APPLICATION OF TEXAS UTILITIES
GENERATING COMPANY, ET AL. FOR
AN OPERATING LICENSE FOR
COMANCHE PEAK STEAM ELECTRIC
STATION UNITS #1 AND #2
(CPSSES)

Docket Nos. 50-445
and 50-446

AFFIDAVIT OF JACK DOYLE

Fig. 2.14—Orientation of the electrode

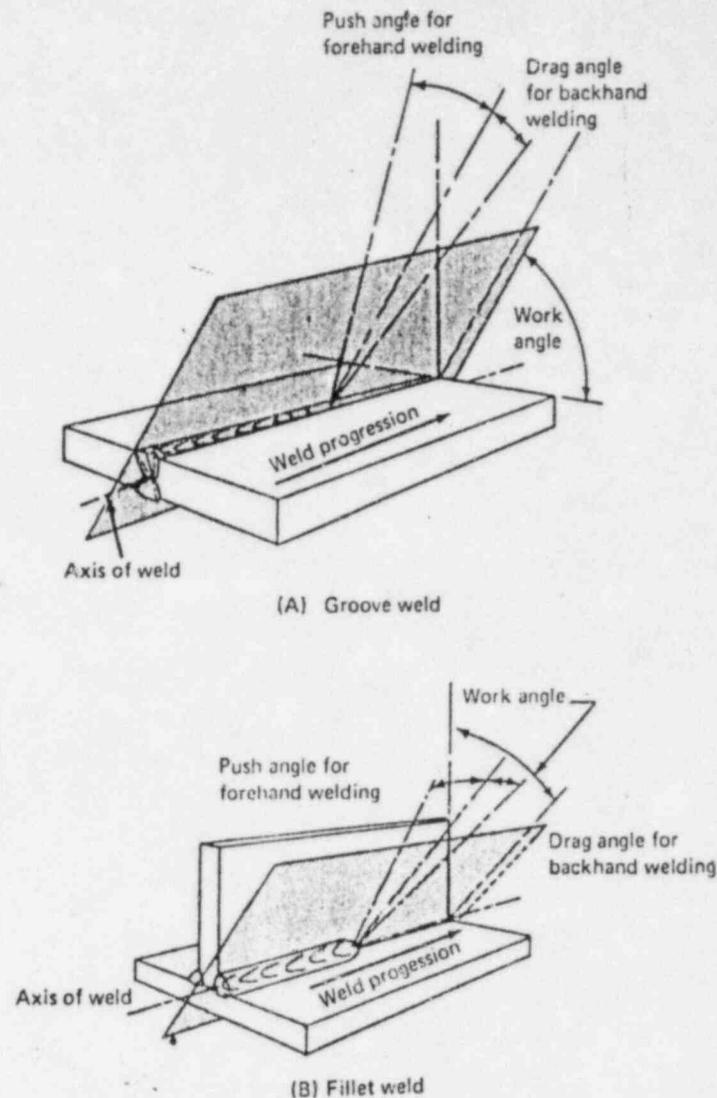
24 Further, on page 71, Figure 2.14 of that document, the orientation for drag
25 angle, push angle, and work angle are diagrammatically depicted. On page

1 72, Table 2.3, the angular limitations for work angle, etc., are given.
2 If the designer is not made aware of welding limitations, then his design
3 will reflect this shortcoming and result in potentially deficient welds.
